City of Burnaby Comments on Trans Mountain’s Response to the National Energy Board’s Information Requests Nos. 1, 2, and 3 on the Burnaby Terminal Variance

The City of Burnaby (“Burnaby”) provides the following comments on Trans Mountain’s responses to information requests no. 1, 2, and 3 of the National Energy Board (the “NEB” or the “Board”) concerning the Burnaby Terminal variance.

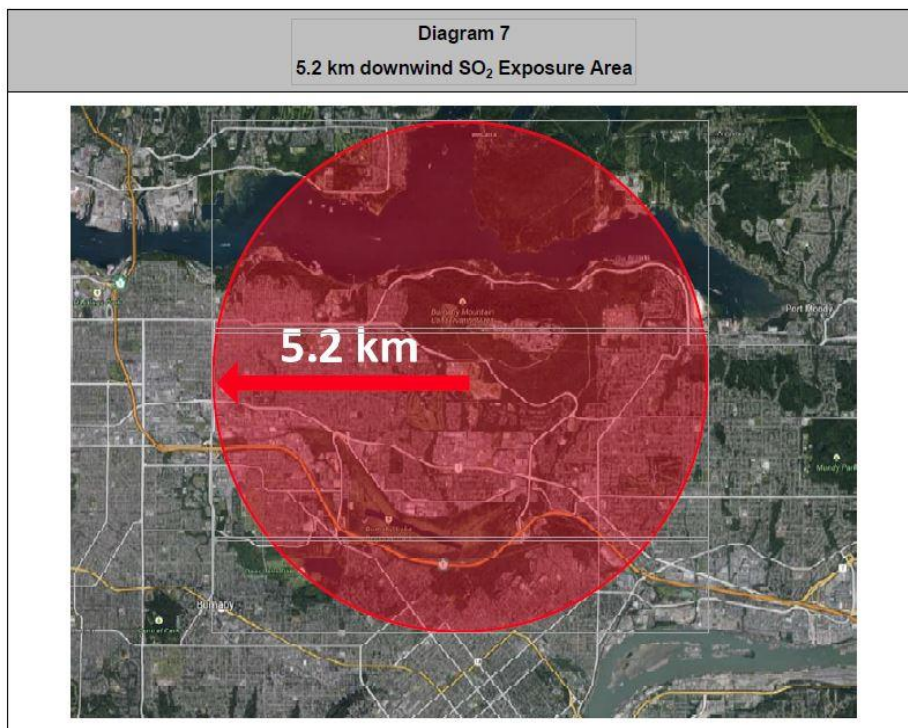
Given the proximity of the Burnaby Terminal to residential neighbourhoods, the toxic exposure effects cannot be neglected in any credible risk assessment of a tank rupture and associated fire event with respect to the Burnaby Terminal. Trans Mountain’s failure to consider this credible risk to Burnaby residents is a serious deficiency in the risk assessment that is of critical concern to Burnaby. Burnaby provided evidence to the Board during the NEB hearing of the risks of toxic exposure in the “Trans Mountain Tank Farm Tactical Risk Analysis” as follows (see pp. 5, 68-73):

Highly toxic Hydrogen Sulfide will very quickly, upon facility release, expose residential areas to conditions that are immediately dangerous to life. Smoke outfalls from fire event may contain Sulphur Dioxide (SO₂), in which KMC analysis shows a potential health concern could be felt up to 5.2 km. downwind.
